Another update on reviewer's comments on:

"The Effects of the Local Environment on a Compact Radio Interferometer I: Cross-coupling in the Tianlai Dish Pathfinder Array"

Peter Timbie, David Kwak

August 15, 2023

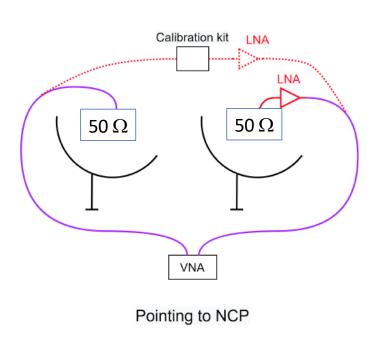
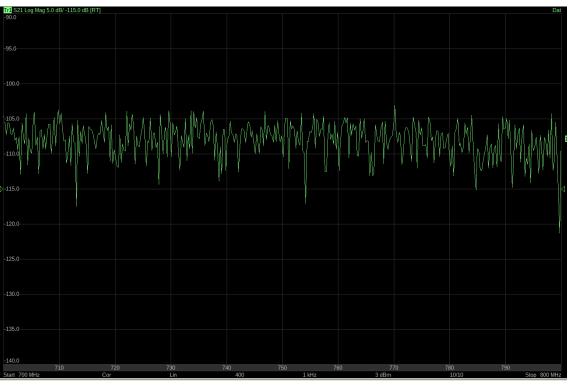
Reviewer's Comment: "Please provide details about the sky map such as the specific source catalog, the model of diffuse emission, and the software used to perform the simulation." Reza? **Reviewer comment:** *"Fig 8: (Now Fig. 11.) the fine scale structures in the S21 parameters look like numerical noise, related to previous discussion, the authors should track down whether this is the case and try to mitigate it. (Peter: David is working on this.) Can the authors confirm that the ripples in the measurement panel are not sourced by cable reflections and uncalibrated spectral structure? Show a measurement where the measurements are terminated by 50 Ohms with nothing else changed so we can see where the systematics floors are. Peter: Fengquan has made such a measurement, showing that the noise floor is about – 107 dB. (Ask David to add a curve to the RH figure showing the noise floor measurement.) Fengquan: The ripple in the S21 parameter is indeed sourced by the uncalibrated spectral structure. The long measurement cable will significantly increase the residual calibration error.*

Should we try to filter out effects of standing waves in the cable?

Fig. 11: Left: Peter: CST simulations of the cross-coupling of baselines 2V-10V (blue), 2V-15V (orange), and 2V-8V (green) when the full array is pointing at the NCP. The baseline lengths are ~ 11.5 m, ~ 20.3 m, and ~ 30.5 m, respectively. Right: Peter: VNA measurement of cross-coupling (S_{21}) of 2V-10V (blue), 2V-15V (orange), and 2V-8V (green) Peter: with dishes pointed toward the NCP. The S_{21} measurements are described in Sec. 5.2. The noise floor of the VNA measurements is ~ -107 dB. (Ask David to add this measurement to the RH figure.) Time averaging was performed only on the noise floor measurements. Although the simulations and VNA measurements do not match in detail, they are at about the same level. Peter: Are these simulations the average of S12 and S21? David will match scales on vertical axes.

Proposed input termination test?

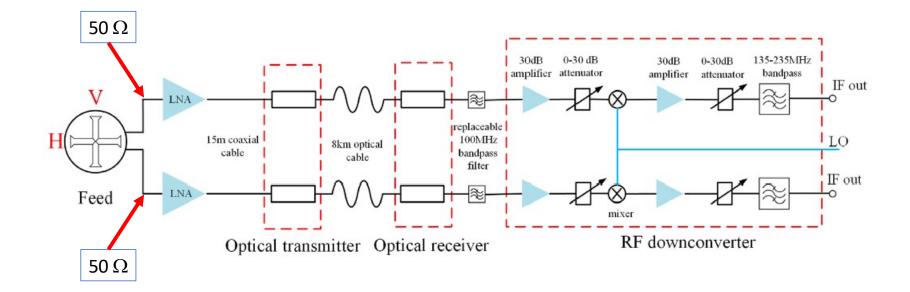
Reviewer proposed this measurement, which Fengquan has done:

Fig. 15: Comparison of the observed nightly mean (blue), cross-coupling (orange), and simulated sky contribution to the visibilities (green).

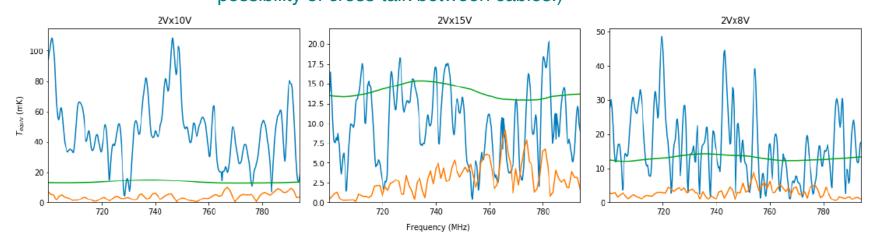
"There is a lot of fine scale spectral structure in the averaged visibilities (nightly mean in current Fig. 15) that is not present in the averaged sky model. Can the authors comment about what the sources of these structures might be? For example, could they be uncalibrated cable reflections? Are they errors introduced by the calibration algorithm / processing?" Peter: We believe these structures are caused by coherent thermal emission from the ground and plan to discuss this model in a future publication. (However, a measurement of the visibilities for these three baselines with the LNA inputs terminated by 50 Ohm loads would allow us to check for cable reflections and for the possibility of cross-talk between cables.)

Fig. 15: Comparison of the observed nightly mean (blue), cross-coupling (orange), and simulated sky contribution to the visibilities (green).

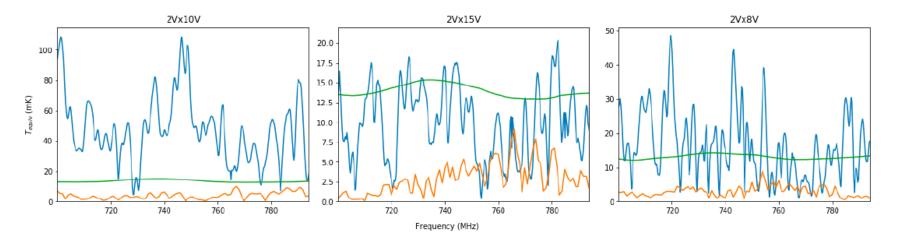
"It looks like both the averaged visibilities and the VNA noise measurements have significant 5 MHz ripples which correspond to roughly to round-trip travel times in 30 meter coax cables. Does the signal chain contain coaxial cables? What attempts were made to calibrate these structures out in both the VNA and visibility measurements?" Peter: This is a good question. We could calibrate it out of the VNA measurements with the 50 Ohm termination test suggested above. We could also measure the effect in the visibilities (nightly means) by terminating the inputs to the LNAs with 50 Ohms. But Albert suggests that calibrating the array on Cas A should remove the effects of cable reflections.
